Technical Note

Project:	Land at Bridge Farm, Twyford	SMA Ref:	5563.TN10-01
Subject:	Review of Reserved Matters Application 260226		
Prepared by:	Rhys Donoghue	Date:	26/06/2026
Revised by:	Rhys Donoghue	Date:	16/07/2026

Extract 3.2 – Drawing PD01.1

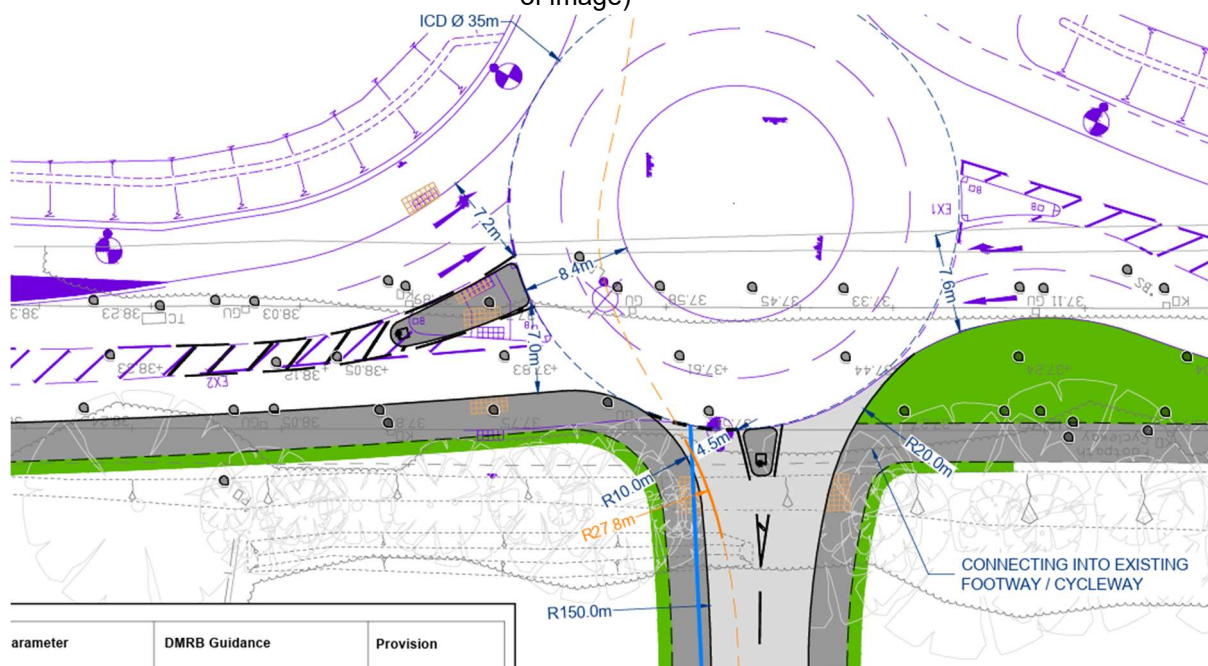
- 3.17. SMA notes that the proposals will change the width of the central refuge on the A4 Western Arm. SMA assumes this is to ensure vehicles turning left out of site are able exit the roundabout without over running the refuge. SMA notes this refuge could be used by cyclists, as such in line with LTN 1/20 guidance, the refuge should have an absolute minimum width of 2.5m (preferred width of 3.0m-4.0m). However, no dimensions of the refuge can be identified on either Drawing PD01 or PD01.1.

- 3.18. As part of the Outline Application, the proposed Northern Arm or Access to the Land to the North of the A4 New Bath Road arm, was shown to have 2 entry arms. This reflected the provision on all other arms including the Land at Bridge Farm Access or Southern Arm. The updated proposals show a single-entry arm. SMA assumes that this is due to the inability to provide a 2-arm approach and still be DMRB compliant.

- 3.19. Clarification is sought from WBC as the LHA, as to whether a single lane approach is suitable for a development of this scale or when considering the volume of traffic on the A4. SMA notes the A4/ Wargrave Road Roundabout to the east of the site has 2 lane approaches on all arms.

- 3.20. The pedestrian and cyclist infrastructure on the Northern Arm does not match the other arms, as pedestrians and/or cyclists will be forced to cross both lanes, without being able to rest in a central refuge. Due to the nature of the roundabout it is possible for motorised traffic to be approaching

the exit arm from multiple directions. SMA would consider this a barrier for vulnerable users which could prevent sustainable access to and from the site, as well as impacting existing users of the shared cycle footway. As such, clarification is sought from WBC if this approach to pedestrian and cyclist connectivity is acceptable.

Extract 3.3 – Drawing PD01.1 (Rotated for ease of review)
(Swept Path Analysis)

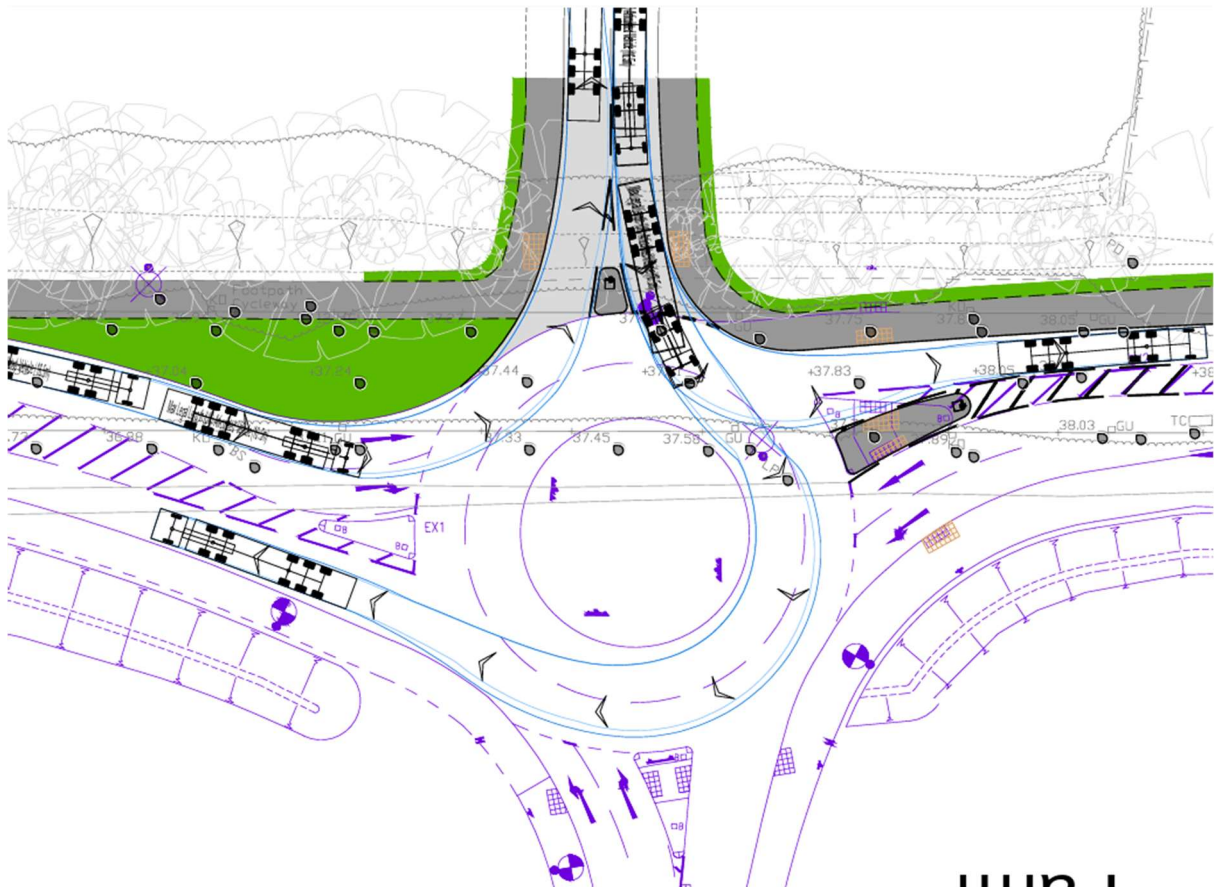
- 3.21. As Extract 3.3 displays, Autotrack Swept Path analysis has been undertaken for a 16.5m Articulated HGV, for manoeuvres into and out of the Northern Arm. SMA notes this Drawing does not show right turns into the site (from the A4 Eastern Arm) or straight ahead from the Land at Bridge Farm Site, although SMA notes this manoeuvre would be unlikely.
- 3.22. When reviewing the Swept Paths, SMA notes the left turn into the site (from the Western Arm) encroaches into the right turn lane. Clarification from WBC is sought as to whether this overhanging is acceptable.
- 3.23. Based on the junction modelling assessment (modelling indicates an RFC of greater than 0.85) and the aforementioned concerns with the vehicle swept path analysis provided. SMA is of the opinion that WBC should provide clarification on whether a larger ICD roundabout should be

provided to accommodate the additional traffic generated by the development and ensure that larger vehicles can safely turn in and out of the proposed development.

- 3.24. At this time without additional information provided by the Applicant, SMA does not believe that the access proposals can be considered safe especially considering the strategic nature of the A4.
